STAFF REPORT

HEARING March 21, 2024

SUBJECT: H-2023-0058 Cityside Storage – MDA,

LOCATION: 2755 N. Eagle Road in the NE 1/4 of

A. Site Plan (12/06/23)

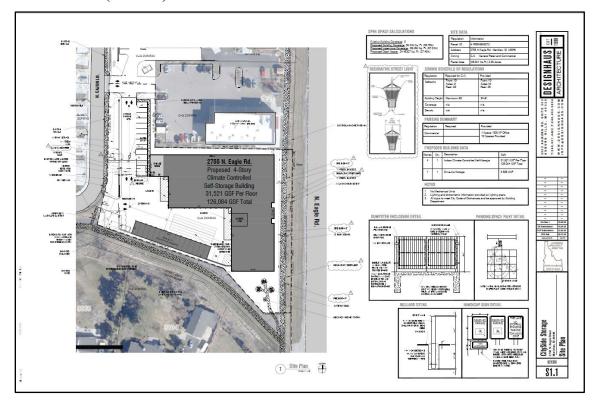
A minimum of one (1) off-street parking space is required for every 500 square feet (s.f.) of gross floor area of the office space – parking is not required for the storage structures. Based on 862 s.f., a minimum of one (1) parking space is required. A total of eight (8) parking spaces are proposed, exceeding UDC the minimum standards.

The site plan depicts a faux stucco wall enclosing the property.

B. Landscape Plan (12/06/23)

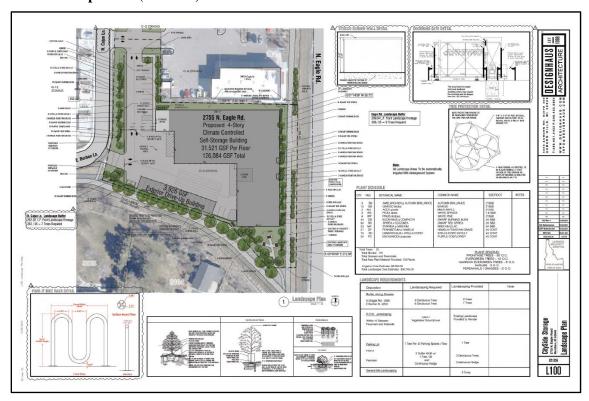
A minimum of one (1) bicycle parking space is required for every 25 vehicle parking spaces per UDC 11-3C-6G. Bases on eight (8) vehicle parking spaces, a minimum of one (1) bicycle parking space is required. A bicycle rack is depicted on the landscape plan.

There is an existing twenty (20) foot landscape buffer with a ten (10) foot detached sidewalk along N. Eagle Road an arterial street. The property owner is proposing an additional ten (10) feet of landscaping along N. Eagle Road which shall be installed per the standards listed in UDC 11-3B-7C.

A 25-foot wide buffer is required to the residential land use to the north as set forth in UDC Table 11-2C-3 and 11-4-3-34F, landscaped per the standards listed in UDC 11-3B-9C.

- 2.3 Add decorative pedestrian lighting along Eagle Road that meet the requirements of UDC 11-3H—4C post and luminaire.
- 2.4 Protect the existing landscaping on the site during construction, per UDC 11-3B-10.

C. Building Elevations (12/06/23) (NOT APPROVED)

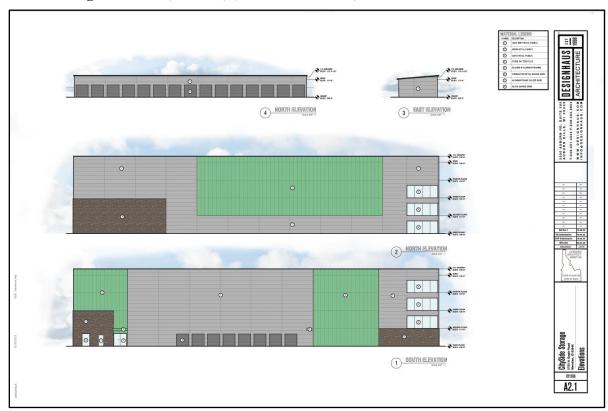
The proposed height will not be harmonious with adjacent residential and commercial uses and will negatively impact these uses as it may lead to overshadowing of neighboring structures, and alterations to the area's character which are a concern. Therefore staff recommends the building height not exceed 35 feet in height which is consistent with the adjacent stuctures in the area.

Conceptual building elevations were submitted for the proposed structure as shown in Section VIII(C). Building materials consist of metal panels and stone pattern tiles. Final design is required to comply with the design standards in the <u>Architectural Standards Manual</u> (ASM) and the recorded agreement.

The images provided by the applicant and staff suggest that the proposed building may not blend well with the immediate area, particularly in comparison to the existing structures. The suggestion made during the preapplication meeting, recommending a design that aligns better with the development on the east side of Eagle Road where multi-story apartment buildings are prevalent, could be a valid consideration.

- 1.1 The new DA shall be signed by the property owner and returned to the Planning Division within six (6) months of the City Council approval of the Findings. The DA shall, at minimum, incorporate the following provisions:
 - a. Future development of this site shall be generally consistent with the concept plan and conceptual building elevations included in Section VIII and the provisions contained herein.
 - b. The future use of this site is limited to the self-service storage facility, office, and retail uses. All buildings shall not exceed thirty-five (35) feet in height.
